| Revisions |          |                                 |       |
|-----------|----------|---------------------------------|-------|
| P02       | 09.03.17 | PLANNING AMENDMENT SUBMISSION   | KI LP |

Client: RFU

Project: TWICKENHAM STADIUM EAST STAND EXTENSION

**DETAILED ELEVATIONS**

**3** ELEVATION  
 CONCOURSE NORTH EAST ELEVATION  
 1:200

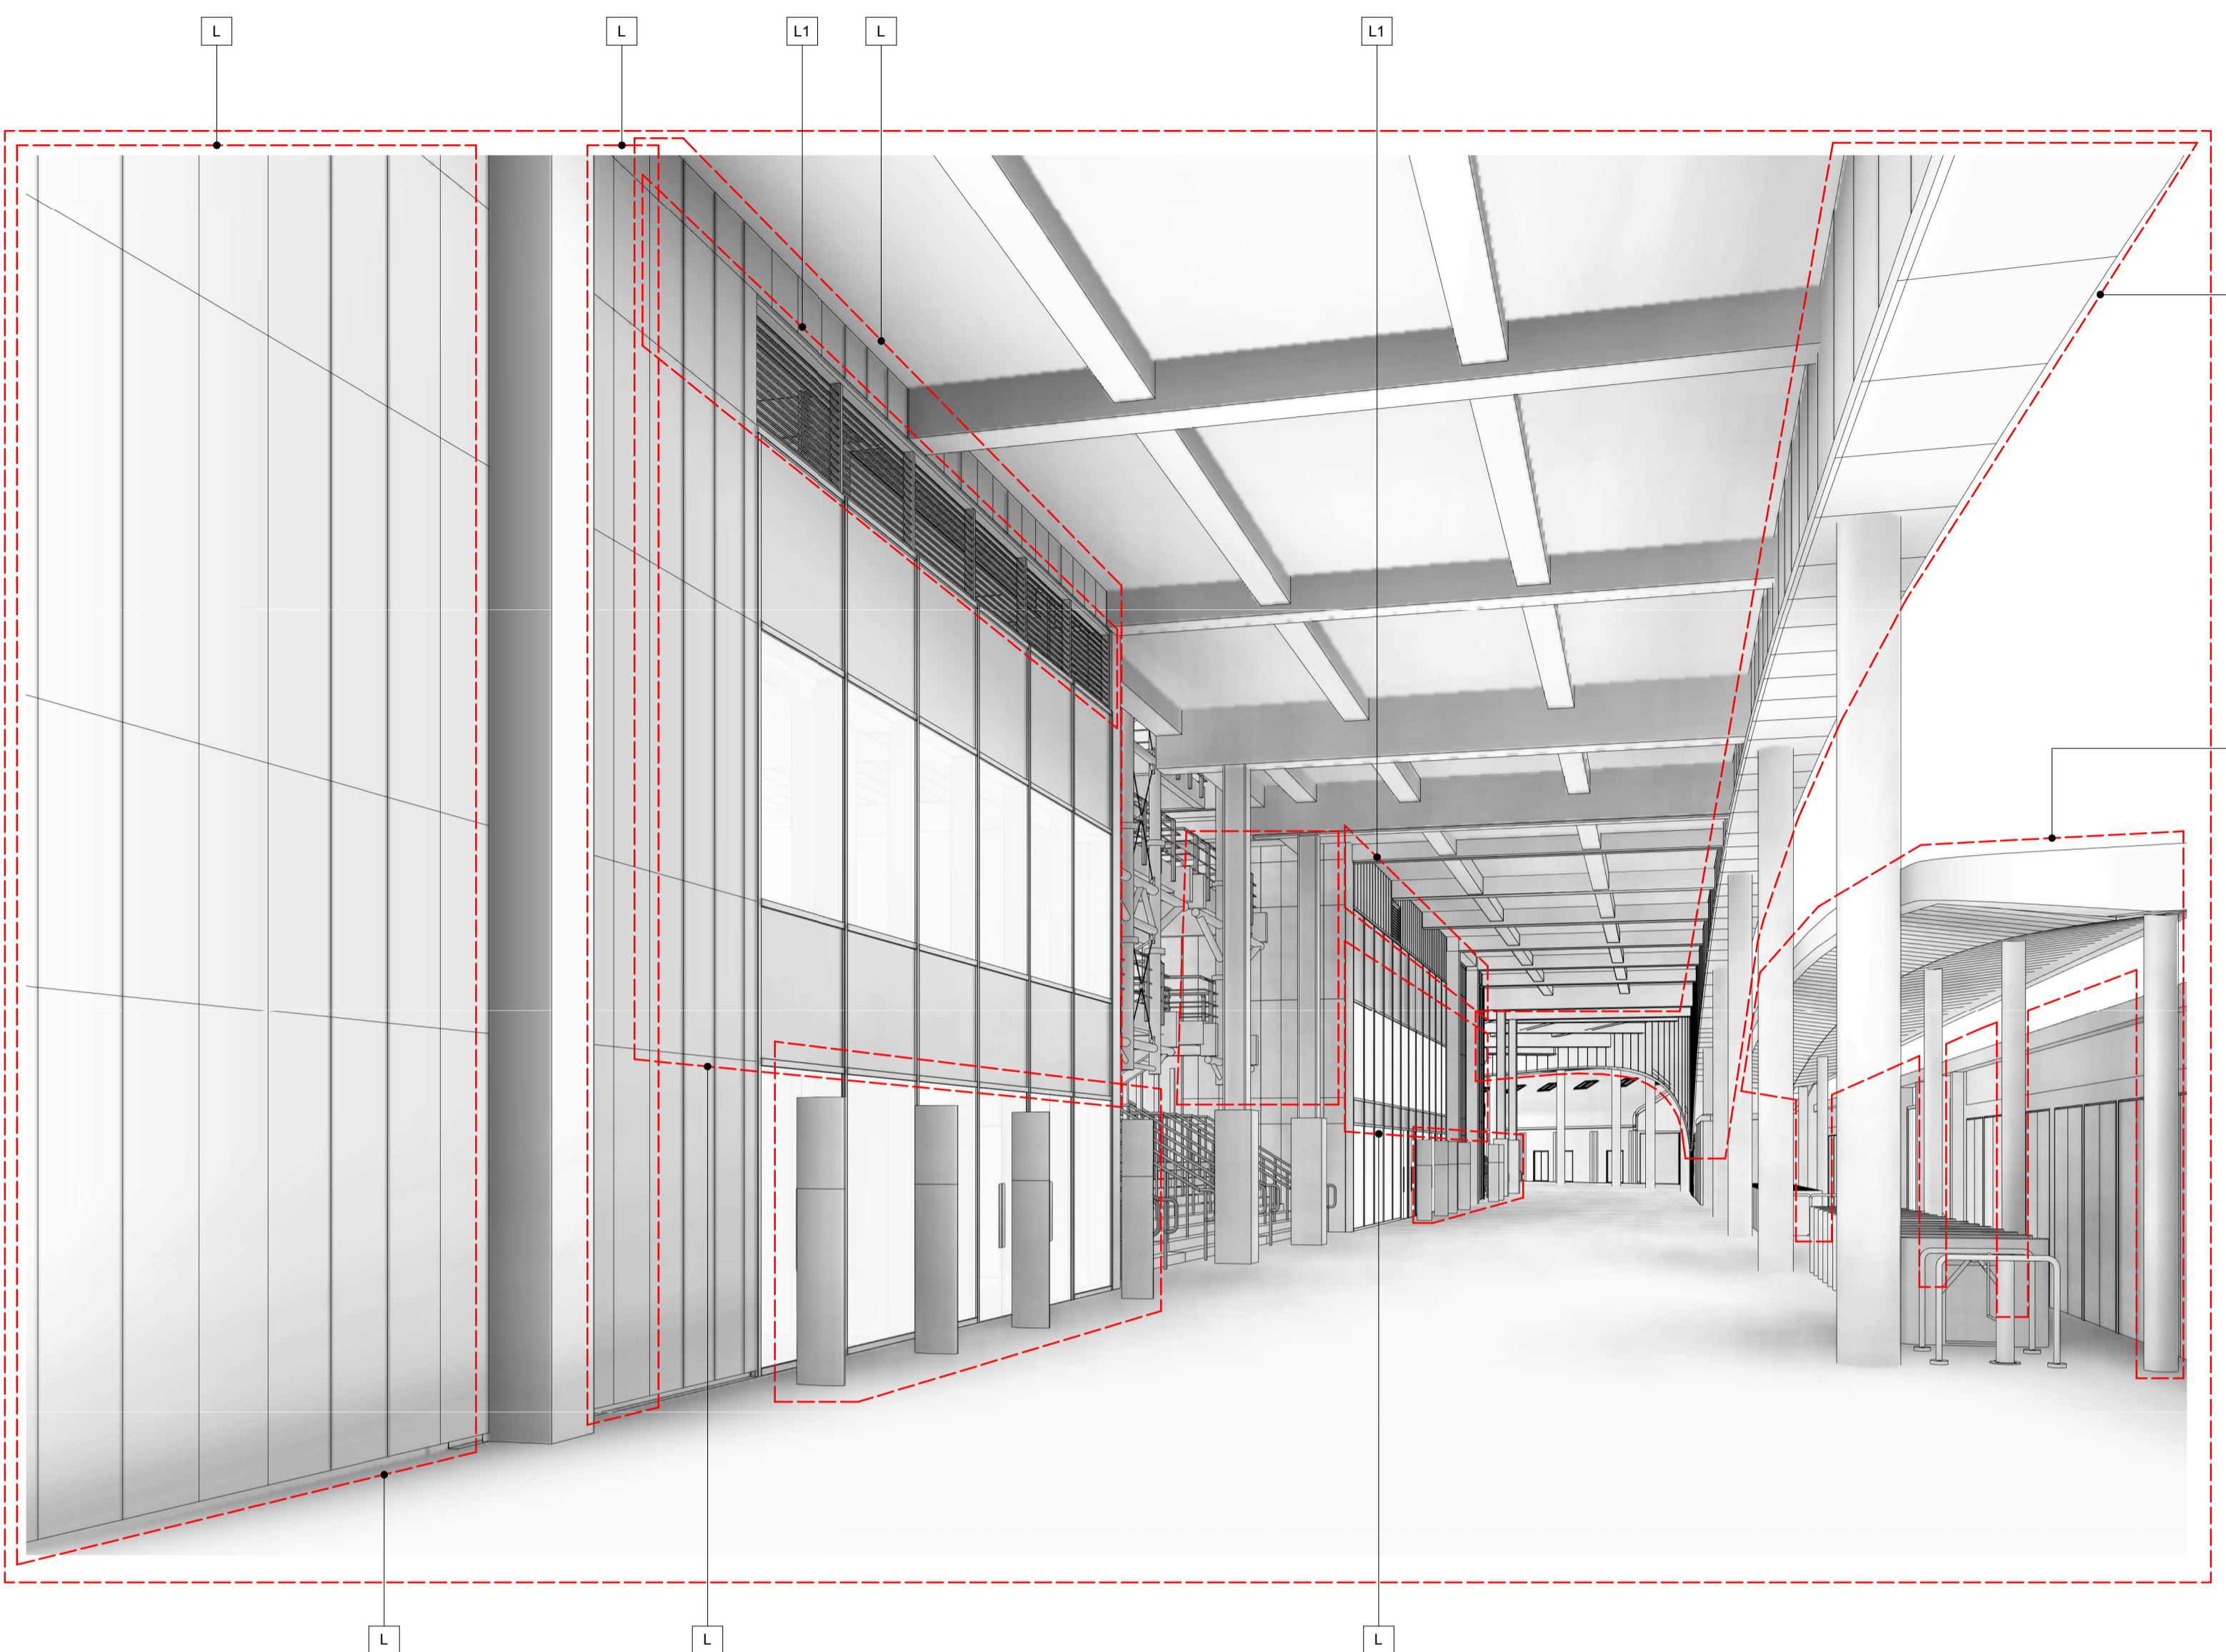
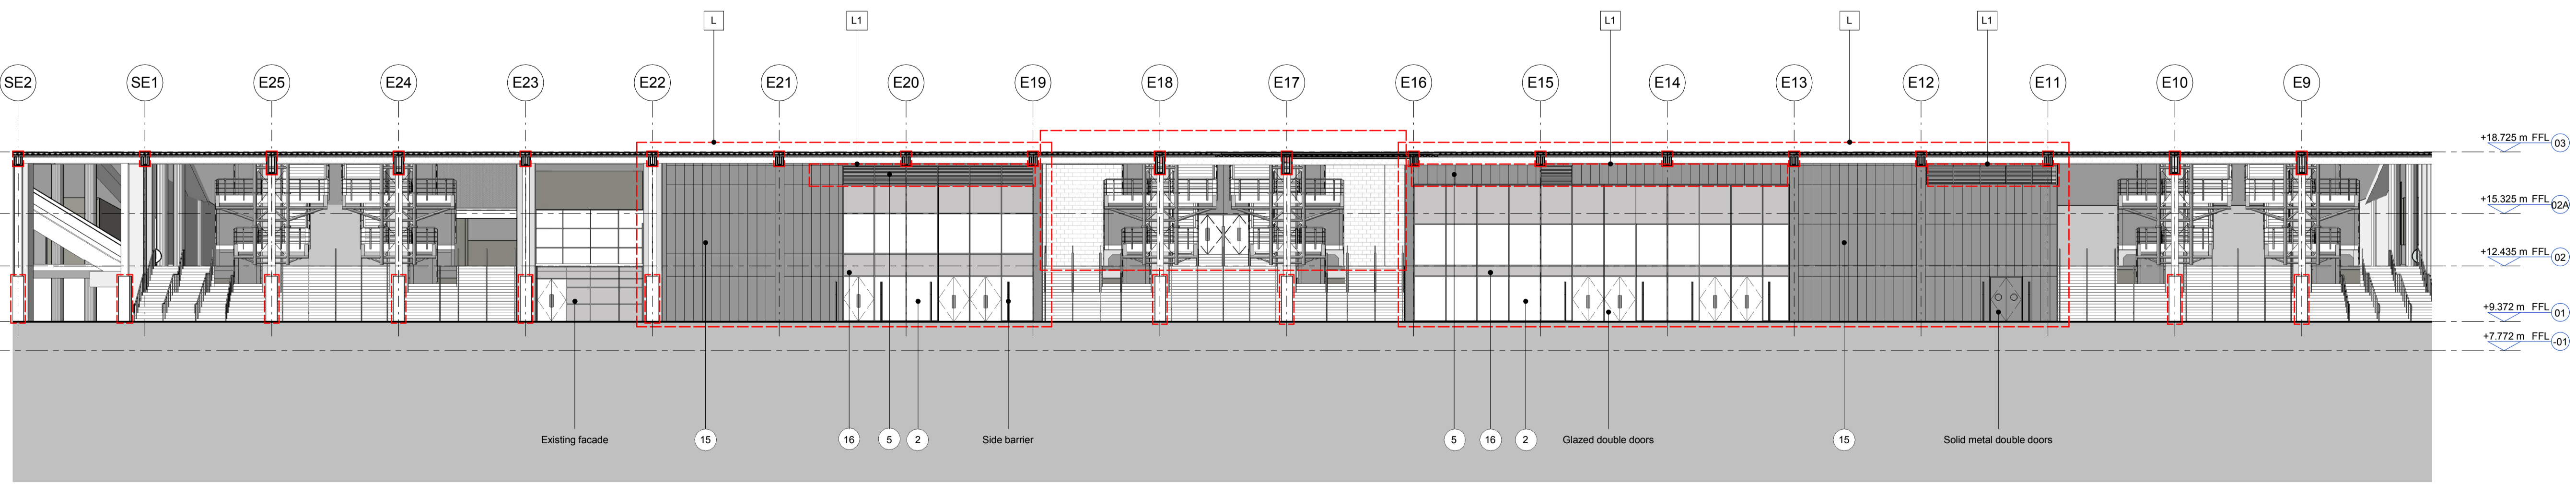
**Revision Notes**

| PLANNING AMENDMENTS |   |
|---------------------|---|
| A                   | GENERAL AMENDMENTS TO THE SOUTH END.  |
| A1                  | INCREASED SHINGLES CLADDING AREA AND CURTAIN WALL REDUCED ACCORDINGLY.  |
| A2                  | REDUCED MASSING AND REVISED INTERFACE WITH THE SOUTH STAND.   |
| B                   | PPC LOUVRES LOCATED TO THE BOWL SIDE HAVE BEEN OMITTED.   |
| C                   | CURTAIN WALL SETTING OUT REVISED GENERALLY. SILICONE JOINTS TO TRANSOMS AND MULLION REPLACED WITH CAPPED SYSTEM LEVEL 04 PPC LOUVRES SETTING OUT & HEIGHT REVISED. MONORAIL FOR ABSEILING REMOVED.        |
| D                   | GENERAL AMENDMENTS TO THE CENTRAL ELEVATION CANOPY AT LEVEL 5A REVISED GENERALLY AND STANDING SEAM REPLACED WITH SINGLE PLY MEMBRANE. SUPPORT COLUMNS TO ROOF CANOPY REVISED. SQUARE FASCIA TO ROOF EDGE. |
| D1                  | LEVEL 5A GLAZED SCREEN EXTENDED IN HEIGHT AND PPC LOUVRES INCLUDED AT LOW LEVEL.  |
| D2                  | INCREASED SHINGLES CLADDING AREA AND CURTAIN WALL AREA REDUCED ACCORDINGLY. FOUR VERTICAL FIN REMOVED.  |
| D3                  | PORCELAIN PANELS WITH SLOTTED HOLES FOR VENTILATION REPLACED WITH PPC LOUVRES EXPRESSED HORIZONTAL PATTERN TO PORCELAIN PANELS OMITTED.   |
| E                   | GENERAL AMENDMENTS TO THE NORTH END   |
| E1                  | PORCELAIN CLADDING REPLACED WITH PPC ALUMINIUM CLADDING.  |
| E2                  | GREEN WALL TO THE NORTH END EXTENDED AND PPC LOUVRES REMOVED.   |
| E3                  | INCREASED SHINGLES CLADDING AREA AND CURTAIN WALL REDUCED ACCORDINGLY.  |
| F                   | FENCELINE, GATE AND PERIMETER COLUMNS SETTING OUT REVISED.  |
| F1                  | CANOPY TO TURNSTILES REVISED.   |
| G                   | PORCELAIN PATTERN CHANGED FROM HORIZONTAL TO VERTICAL.  |
| H                   | PORCELAIN PANELS TO THE SOFFIT OF THE ARCH REPLACED WITH PPC ALUMINIUM PANELS. PORCELAIN PANELS SETTING OUT REVISED.  |
| K                   | ROOF TO LEVEL 5A (NORTH END) EXTENDED.  |
| L                   | GLAZED SPANDREL PANELS REPLACED WITH METAL SPANDREL PANEL. PORCELAIN PANELS REPLACED WITH PPC ALUMINIUM CLADDING.   |
| L1                  | PPC LOUVRES INCLUDED FOR MECHANICAL VENTILATION.  |
